MITSUBISHI HEAVY INDUSTRIES, LTD.
16-5, KONAN 2-CHOME, MINATO-KU
TOKYO, JAPAN

Docket No. 52-021
MHI Ref: UAP-HF-11091

Subject: **Transmittal of the Updated Tier 2, Chapters 9, 10 and 12 of US-APWR DCD**

Update of Tier 2, Chapter 9 of US-APWR DCD

Figure 9.2.6-1 Condensate Storage Facilities System Flow Diagram

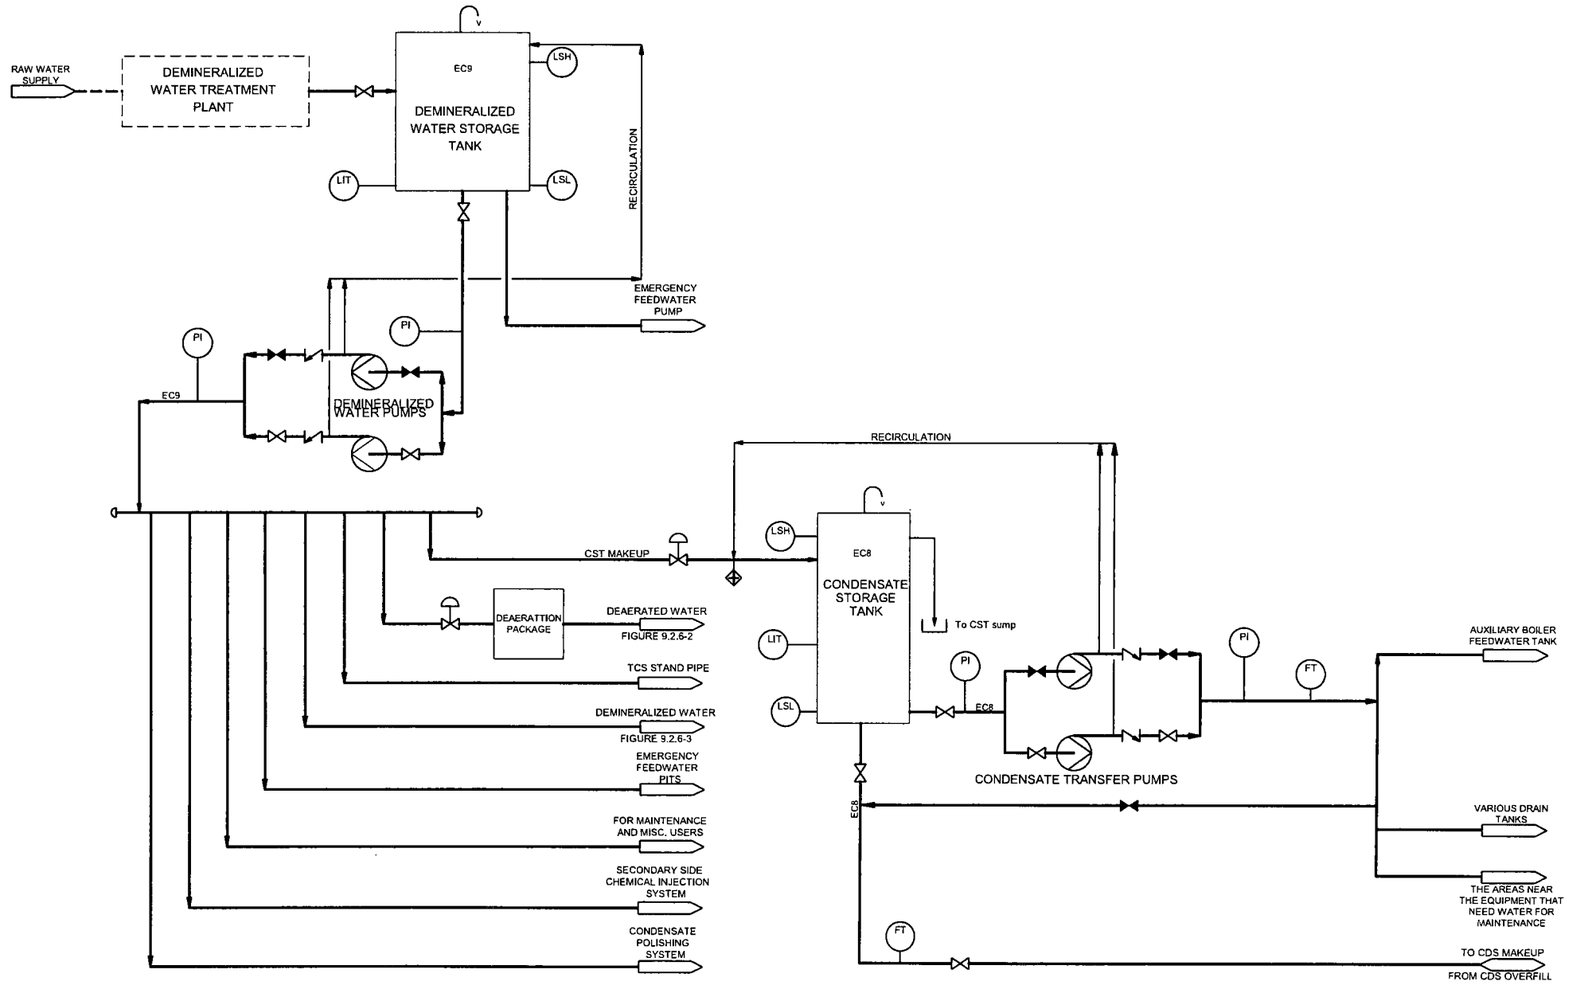
The CST is the normal source of water for make up to certain plant systems including the main condenser. The CST is a source of water for supply to various locations such as areas near equipment that need water for maintenance and drain tanks. Makeup to the CST is provided from the DWST. The CST overflow goes to a dike which is provided to control the release of chemicals and radioactive materials. This CST overflow is directed to the Condensate Storage Tank sump inside the dike area. The sump is equipped with a level instrument to detect fluid level and initiates alarms via representative alarm in the MCR for operator actions to stop condensate transfer and to investigate the extent of condition. After analysis for level of contamination, the content inside the dike area can be trucked to WWS for disposal; or to the LWMS for treatment and release.

RCOL2_12.03-12.04-11 S02

RCOL2_12.0
3-12.04-11
S02
